Assessment of Geomechanical Properties, Maximum Depth below Ground Surface and EDZ Impact on Long Term Safety

Expertenbericht

Sachplan Geologische Tiefenlager, Etappe 2

ENSI Report No. 33/460

Figure 2: a) Data basis used for establishing unconsolidated undrained shear strength values for various water contents (NAGRA 2014a); b) Fitting of data for establishing the matrix strength of different rock mass types (GM1 to GM6).

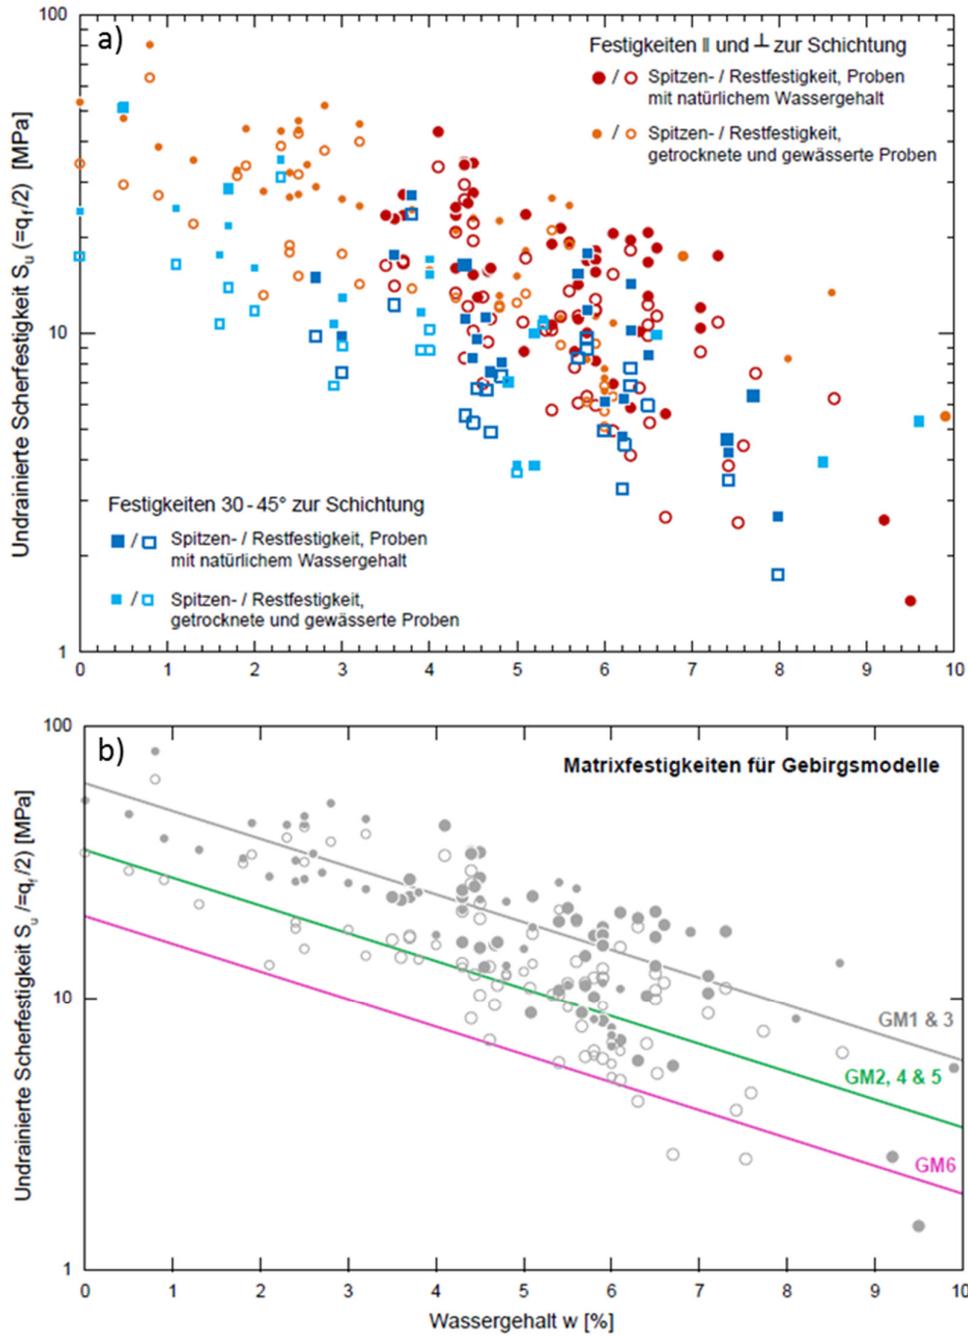
The data basis used to establish the unconsolidated undrained shear strength S_u is largely not appropriate. As shown by Amann and Vogelhuber (2015), the majority of specimens were not saturated and the resulting S_u values overestimate the actual S_u due to capillary forces (suction). A consistency test revealed that the suggested S_u values for the intact matrix and bedding planes are between 1.2 – 2.0 times larger than the S_u values calculated by Amann and Vogelhuber (2015) from the related effective friction angles and effective cohesions suggested by NAGRA. For the calculation, Amann & Vogelhuber (2015) assumed zero volumetric strain and a linear-elastic, isotropic material behavior (i.e. the same assumption as for the effective stress calculations utilizing FLAC2D). Valid consolidated undrained (CU) triaxial test results from Jahns (2013), Aristorenas (1992) and Wild et al. (2015) were used by Amann and Vogelhuber (2015) to develop a relationship between S_u values obtained from P- and S-specimens and the effective stress. A linear increase of S_u with increasing effective confining stress was assumed. This analysis shows that the S_u values suggested by NAGRA are significantly larger than the S_u values obtained from valid triaxial tests. Owing the inappropriate data base and the above described inconsistencies, the suggested S_u values, as proposed by the NAGRA, overestimate (partly significantly) the actual undrained shear strength of the intact matrix and the bedding planes.

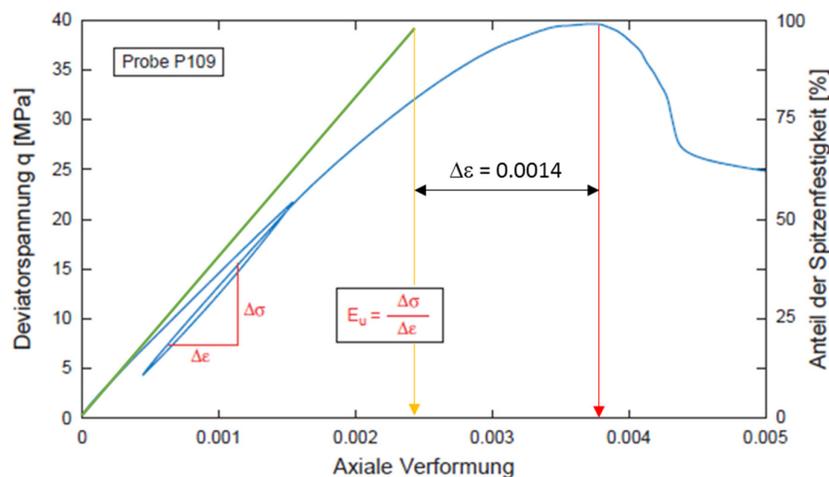
The blue line represents the behavior of specimen P 109 (Jahns 2013). The green line represents the response of a specimen assuming linear-elastic behavior (i.e. no plastic deformation in the pre-peak region) using an E-Modulus obtained from an unloading/reloading cycle. The axial strain at failure in the model (at 0.24%) differs by 0.14% from that in the actual triaxial test (at 0.38%). This means that the value in the model corresponds to only 64% of the value in the actual triaxial test. Thus, the simplification may lead to a relevant underestimation of the pre-peak deformation and therefore to a relevant overestimation of the stiffness of Opalinus Clay which needs to be considered in numerical and analytical engineering design calculations.

Figure 4: Calculated unconfined compressive strength for suggested effective strength properties of the matrix (a) and bedding (b) for Opalinus Clay shallow and deep and the various rock mass models as proposed by NAGRA (Nagra 2014a)

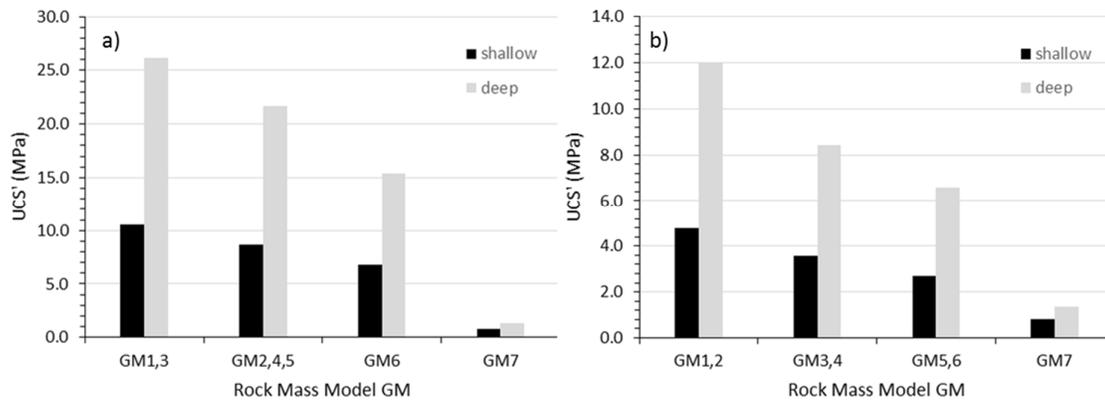
The degradation of matrix and bedding strength is shown in Figure 4 based on the unconfined compressive strength (UCS) calculated from the effective friction and effective cohesion suggested by NAGRA for each GM. The calculated strength degradation with respect to the intact matrix strength (GM1,3) for shallow/deep are 18/17% for GM2,4,5, 35/41% for GM6 and 92/95% for GM7. The calculated strength degradation with respect to the intact bedding strength (GM1,2) for shallow/deep are 25/30% for GM3,4, 43/45% for GM5,6 and 83/89% for GM7.

As shown by Amann and Vogelhuber (2015), the suggested effective strength properties of the intact Opalinus Clay, which form the basis for strength reduction, tend to overestimate the actual strength. As a consequence, the suggested rock mass properties also tend to overestimate the actual rock mass strength.

Figure 5: Suggested S_u values versus water content of the matrix (a) and bedding (b) for the rock mass models. The S_u values were calculated from the relations given in NAGRA 2014a.

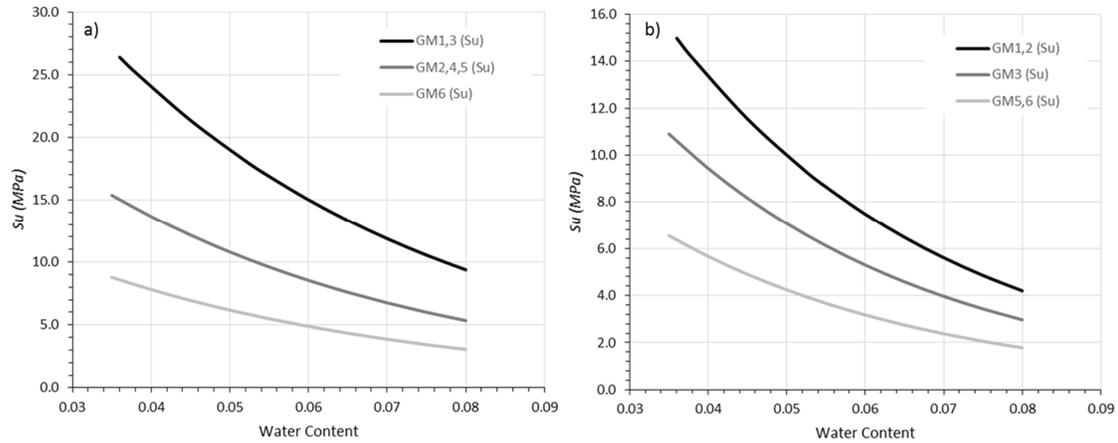
The S_u values suggested by NAGRA for the various rock mass models depend on the water content (Giger and Marschall 2014) and are shown in Figure 5 for both matrix and bedding strength. The strength degradation with respect to the intact matrix strength (GM1,3) is independent of the water content and is 43% for GM2,4,5 and 67% for GM6 (S_u for GM7 was not defined). The strength degradation with respect to the intact bedding strength (GM1, 2) is 39% for GM3, 4, and 57% for GM5, 6. The quantity of strength degradation to account for rock mass weaknesses is largely inconsistent between S_u and the effective strength. In addition, calculated S_u values from effective strength properties should be consistent with the suggested S_u values. Table 5 shows S_u values calculated from

Consistency between suggested and calculated S_u values only exists for the matrix strength of GM 2,4,5, and the bedding plane strength of GM 3,4 for water content at 900 m depth, and the bedding plane strength of GM 5,6 for water content at 500 m depth. As a consequence, the suggested S_u values are considered unreliable because of the following points: 1) the inappropriate data basis used for establishing S_u , and 2) the inconsistency in strength degradation between effective strength properties and undrained shear strength.

Figure 7: Reference, minimum, and maximum stress scenarios with depth used in the numerical modelling by NAGRA (from Giger and Marschall 2014).

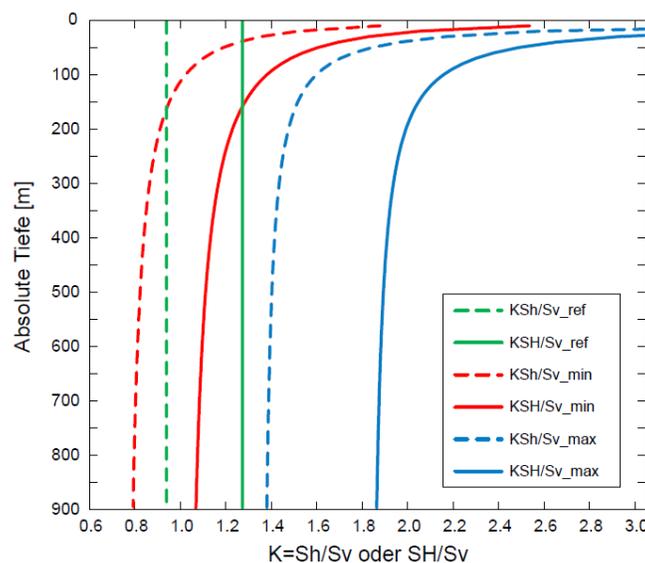
Assuming a constant ratio for SH/S_h (equal 1.35) based on hydro fracturing measurements from the Benken borehole represents a reasonable assumption, however some uncertainty exists since Giger and Marschall (2014) state that the SH/S_h ratio could be as high as 1.6 based on borehole breakout analysis. The uncertainty of this assumption and the variability of the stress magnitudes on a site specific basis are not discussed and whether new interpretations replace previous findings.

Figure 13: Ground reaction curves for GM 3 rock mass properties and two different values for the E -Modulus. The diametral strain increases substantially and exceeds the allowable limits of design indicator EI-2. The radius of the plastic zone, however, remains constant.

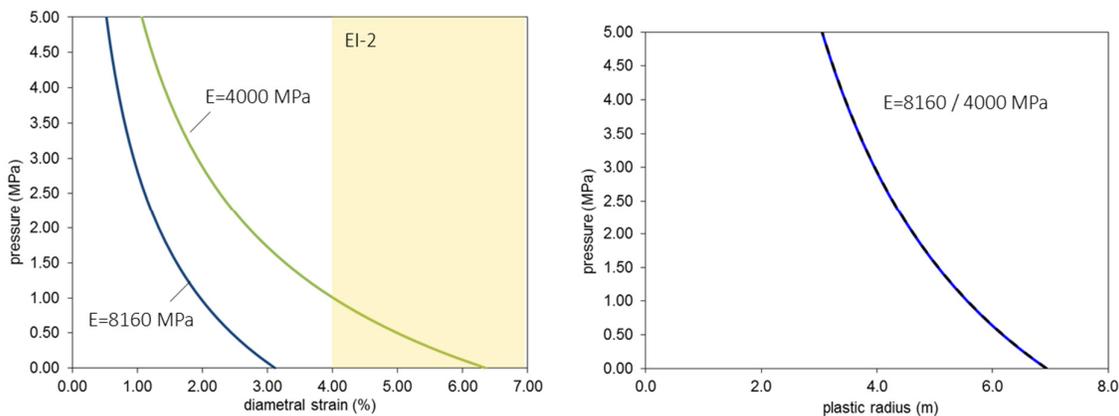
In the theory of the GRC (i.e., assumptions are an infinite long circular tunnel, rotation symmetry, a hydrostatic stress state, an elasto-plastic constitutive law) the radial displacements are indirectly proportional to the E -Modulus. Assuming zero dilation, a reduction of 50% of the E -Modulus leads to a duplication of radial displacements; the radius of the plastic zone, and the accumulated volumetric plastic strain in the EDZ, however, remain constant (see Figure 13).

The use of a tunnel strain criterion to assess the hydraulic conductivity and conductance of the excavation damage zone is not acceptable, in particular because robust relationships between hydraulic conductivity of the EDZ, EDZ area and tunnel strain have not been established and the assessment is significantly dependent on the E -Modulus used in numerical analysis.

Figure 14: Accumulated plastic shear strains (bedding) at the time of support installation (70% relaxation is assumed) at a depth of 800 m. The calculation is based on GM 3 properties.

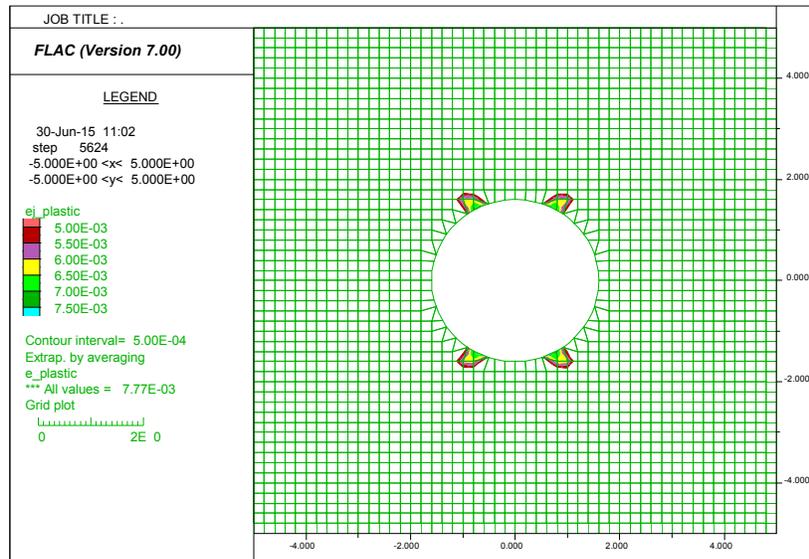
Conditions for sealing installation were assessed using an accumulated, averaged tunnel strain criterion. An accumulated tunnel strain before support installation $u(e)/a < 1\%$ was targeted for an unsupported tunnel (i.e. classified as “favorable”), and the maximum allowable accumulated strain before support installation was defined to be $u(e)/a < 2.5\%$ (classified as “less favorable”). The derivation of these limits are based on stress-strain curves from compressive strength tests in the laboratory, where the residual strength is typically reached for strains in the order of 1%. The axial strain measured in triaxial compression tests in the laboratory cannot be directly compared to a tangential tunnel strain and thus cannot be directly converted into a diametral tunnel strain criterion NAGRA (2014b) also provides examples of unfavorable or unacceptable situation for sealing installations (Figure 12). All examples show local failure phenomenon rather than global failures, which questions the use of an average tunnel strain criterion as defined in Figure 11. Locally the strain around the excavation may exceed the strain required to reach the residual strength, but the average tunnel strain can still be moderate or low. This

is illustrated using the example⁵ shown in Figure 14. A circular repository tunnel with a radius of 1.6 m was assumed in an isotropic effective stress field representative for a depth of 800 m. GM3 rock mass properties were utilized as defined by NAGRA (2014b). The residual strength is assumed to be reached for an accumulated plastic shear strain $\gamma_{plast} = 0.01$ for the matrix, and $\gamma_{plast} = 0.005$ for the bedding planes (NAGRA 2014b).

The example shows that the tunnel strain (in this case the maximum strain that accumulates without support measure) is 0.32% at support installation (70% relaxation was assumed). Within the rock mass, however, the residual strength for the bedding is reached locally indicated by the colored areas. Even though the tunnel strain criterion suggests favorable conditions at support installation (i.e., $u(e)/a = 0.32\%$), the residual strength in the bedding planes is reached. Note that the assessment of $u(e)/a$ depends on the assumption of the amount of deformations which occur ahead of the tunnel face or before support installation. For the FLAC2D calculations of NAGRA (2014b) it is not clear which assumptions have been made.

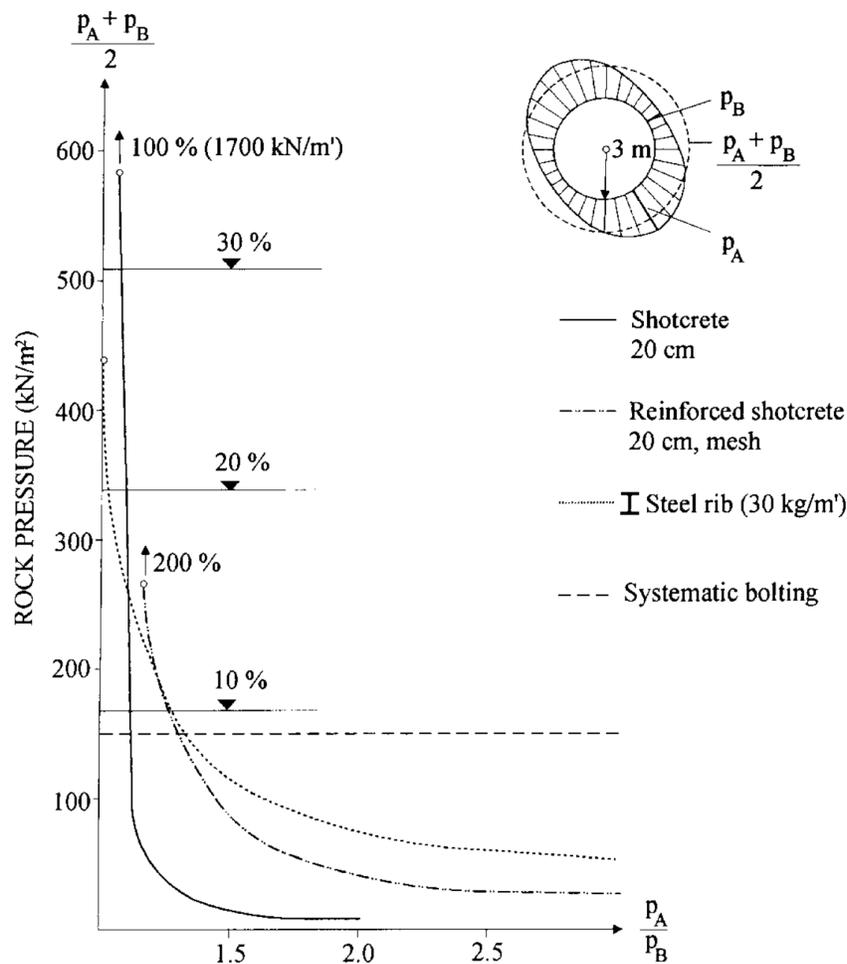
The limitations of the ground reaction curve are discussed by NAGRA (2014b) (i.e., the anticipated ground behavior and boundary conditions deviate significantly from the assumption of an isotropic stress state and uniform radial displacements/pressure distribution). Reduction factors for the maximum load bearing capacity of the lining were introduced according to Kovári (1998) to account for the anticipated ground conditions that leads to non-uniform displacements (i.e. non-uniform distribution of rock pressure due to anisotropic rock mass strength, deformability, and in-situ state of stress). A factor of 1.3 was assumed for the non-uniform pressure distribution (i.e. P_A/P_B , Figure 15, Kovári and Staus 1996).

The maximum load bearing capacity for both shotcrete and steel arches was reduced by a factor of 2, and for concrete segments a factor of 0.66 (due to the low bending stiffness) was assumed. For the structural analysis GM3 rock mass properties at the Xk level were used (bedding plane strength).

Kovári (1985) states that for non-uniform load distributions the GRC is not directly applicable and more or less arbitrary assumptions have to be introduced, which are not further discussed in Kovári (1985). In these cases finite element codes with advanced constitutive relations should be used for a correct analysis.

Figure 16: Comparison in diametral tunnel strain assuming persistent and non-persistent joint elements in Phase2.

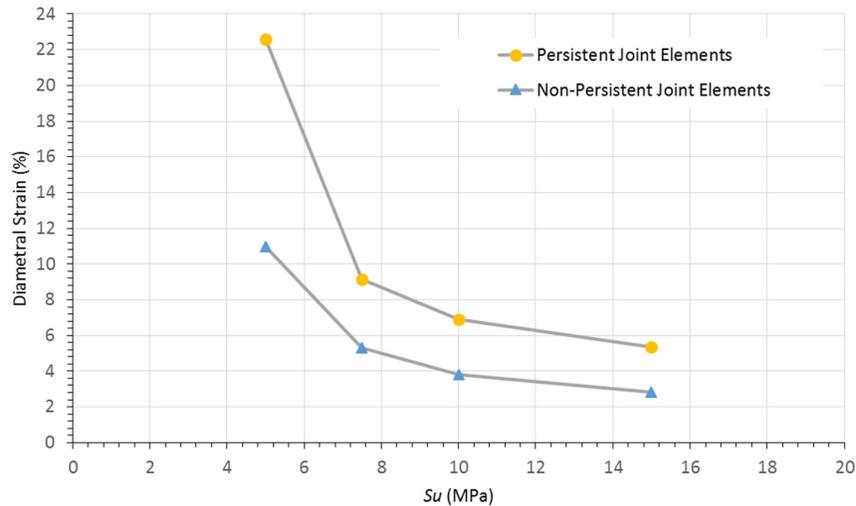
The impact of joint element persistence on the calculated diametral tunnel strains is shown in Figure 16¹¹. The calculated tunnel strains differ between models assuming non-persistent (50%) and persistent joints depending on the S_u by 2.5 % to 11 %.

Figure 25: Three fundamental long-term mechanical effects (creep, stress relaxation, strength degradation) on the EDZ expressed in terms of strain-time and principal stress space (after Paraskevopoulou et al. 2015).

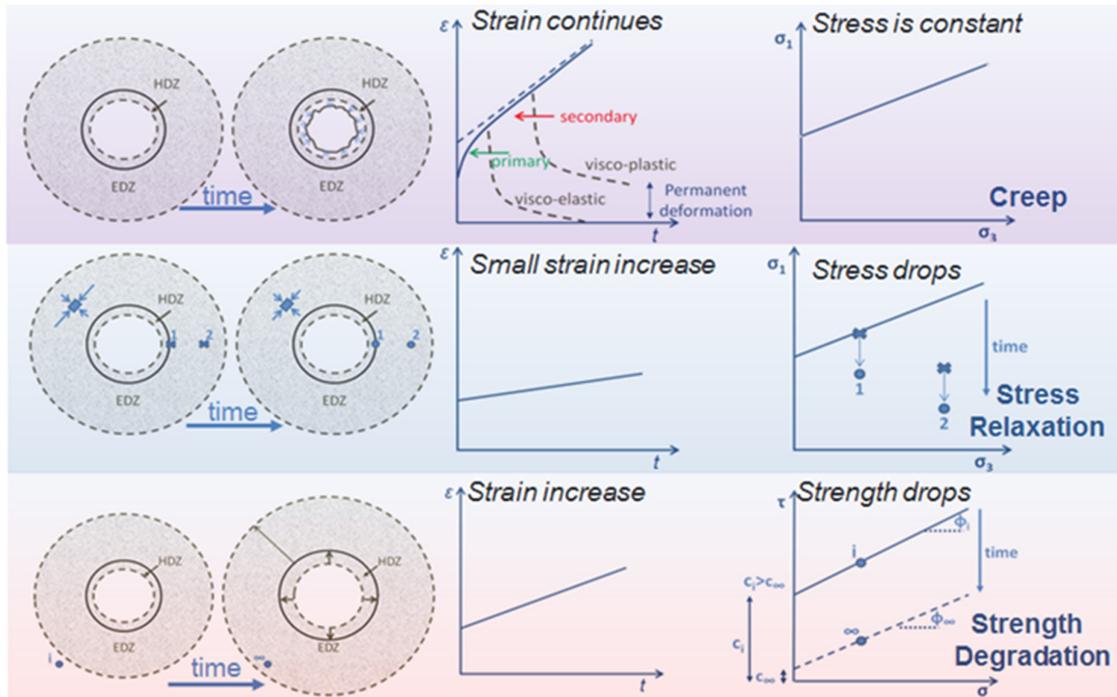
Long-term strength degradation is a reduction of the mechanical properties of the rock mass from peak to residual with time within the plastic yield zone. This is distinguished from plastic yielding due to stress re-distribution from the initial excavation process and affects the damaged rock mass within the plastic yield zone whose mechanical properties are not yet at residual level. This is an important process occurring in brittle rocks and can be caused by a number of environmental (e.g. humidity fluctuations) and geochemical processes happening within the EDZ with time. Figure 25 shows how some of these mechanisms influence the yield envelopes with time and the changes that could occur to the EDZ.

Figure 25 and most investigations carried out in the past by NAGRA are related to an EDZ, which is composed of variably fractured material, but not containing any overbreak or material missing from the outside the designed perimeter of the excavation. As shown in various reports and discussed in section 3, structurally and stress controlled failures can lead to buckling, slab or wedge failures creating large overbreak. In extreme situations these damage zones can reach dimensions of up to 3 excavation diameters (Kupferschmied et al. 2015). Such large overbreak is of very high significance for long-term safety, because they can seriously impact bentonite buffer support pressure and self-sealing of EDZ fractures, if not backfilled properly.
